3.0 Schematic Requirements

TITLE: BLE Beacon
SIZE | DWG. NO. | REV

TITLE: Beacon_IN100_schematic		REV: 1.0
	Company: PoClab	Sheet: 1/1
	Date: 2022-09-05 Drawn By: yankobogdan

C3-10uF Reference

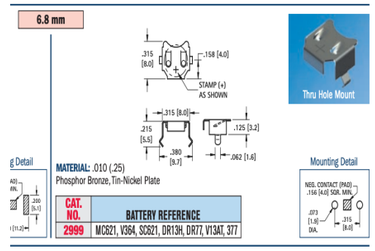
*PCB 1oz. 1.6mm FR-4
*1.5V power it's ok

BAT_HOLDER

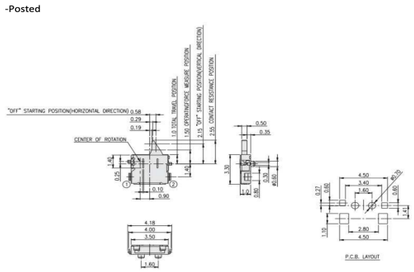
*design battery holder

BUTTON_#1

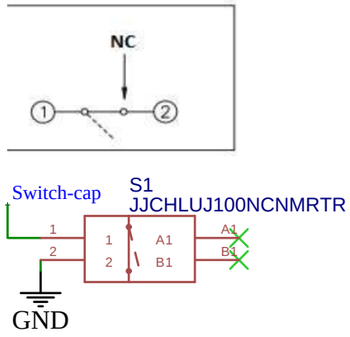
*design JJCHLUJ100NCNMRTR
*normal closed

BUTTON_#2

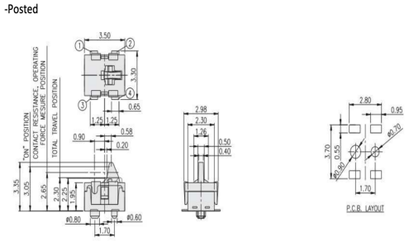
*design JJBV0UG335NONPRTR
*normal open
